Work Order ID 101050

Item Name: Replacement Skidtube

DRAWING NO. D2580	TITLE 205 SKIDTUBE ASSEMBLY	REV. E	DART AEROSPACE LTD ENGINEERING ORDER	D.E.O. NO. D2580-E-1	SHEET NO SHEET 1 OF 1	SCALE NTS
DRAWN <i>UP</i>	CHECKED <i>ASS</i>	MFG. APPR. <i>ER</i>	APPROVED <i>[Signature]</i>	DE APPR. <i>[Signature]</i>		
DATE 11.12.13	DATE 11.12.13	DATE 11.12.13	DATE 11.12.13	DATE 11.12.13

D2580-041 ASSEMBLY DETAIL

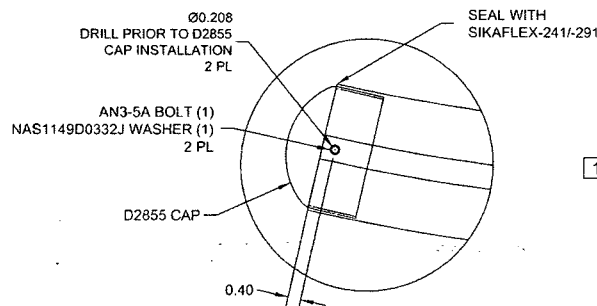
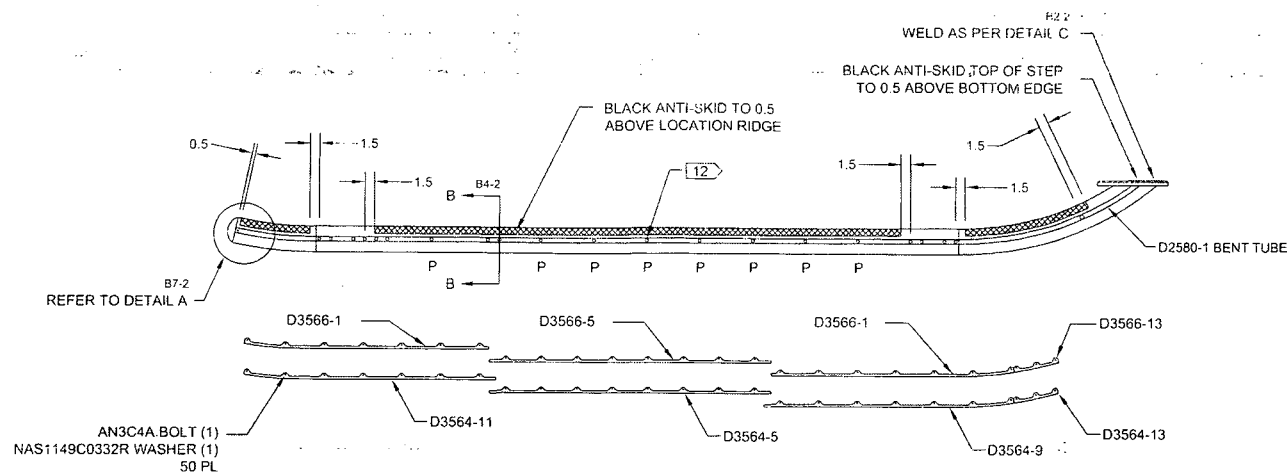
- AFTER DRILLING AND BENDING ASSEMBLY
PERFORM THE FOLLOWING FOR Ø0.508 HOLES ONLY:
1. CHAMFER HOLE 0.050 X 45°
 2. INSERT D2579 SPACER (20 PLACES)
 3. WELD INTO PLACE AND GRIND FLUSH
 4. C-BORE D2579 SPACER TO Ø0.437 X 1.00 DEEP

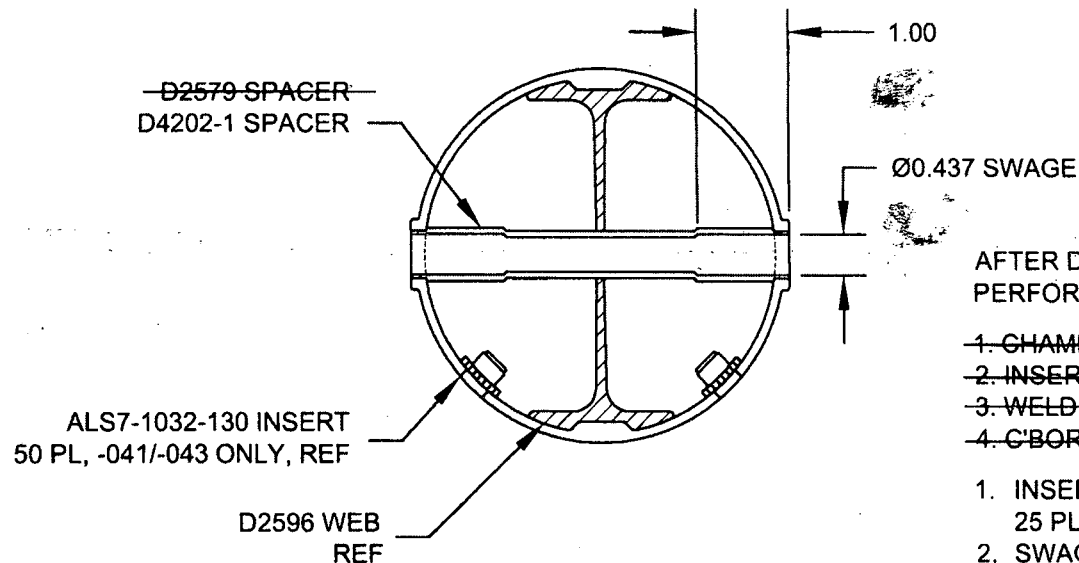
CHANGE ALL C'BORED WELDED CROSSBOLT SPACERS TO SWAGED SPACERS

SECTION B-B, SECTION F-F, & SECTION I-I ARE AMENDED AS FOLLOWS
FOR ALL HOLES THAT WERE ORIGINALLY C'BORED:

*** FOR -045 SKIDTUBE ONLY:**

WELD 4X D2579 SPACERS PER DWG
IN LOCATIONS MARKED "NO C'BORE".
REF SHEET 4 OF DWG.
